Access Compliance Report Public Rights-of-Way (Pedestrian Signals)

Main Street: CROWN_VALLEY_PKWY Cross Street: SIENNA_PKWY Location: N

ADA ID: SGRK211022112405 Signal Type: One Push Button-Non APS Overall Compliance: No Severity Scores: BTN 1: 35 BTN 2: N/A No BTN: N/A

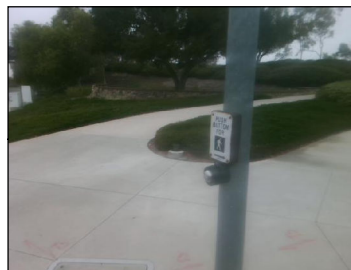
OC Std/PROW: R404.1, MUTCD 4e.08

Possible Solutions: Replace Signal Push Button With APS Button. Provide Clear Space.
